FT5073 Clamps are too small for the elbow of the CAC pipe

DCP-507601

Replace CAC pipe clamps at radiator

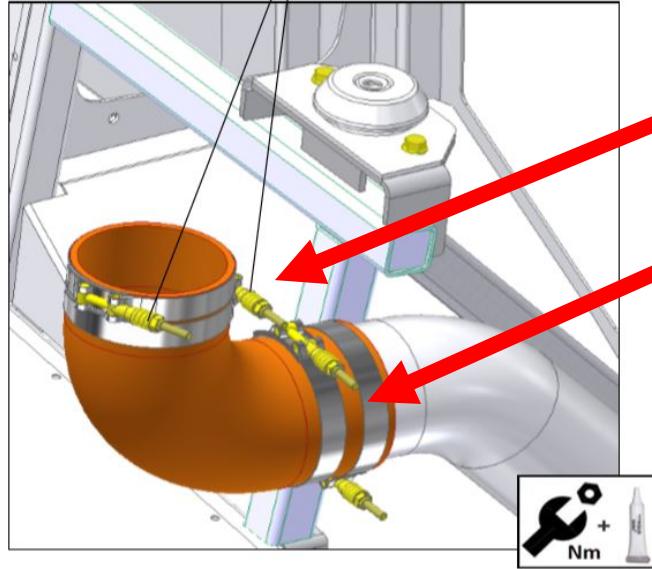
DCP-507601 Change Clamps (4X) from N99800 to N620000051

4 TORQUE
 $13.5 \pm 2 \text{ Nm}$
SEE NOTES 3, 4, 5, 6
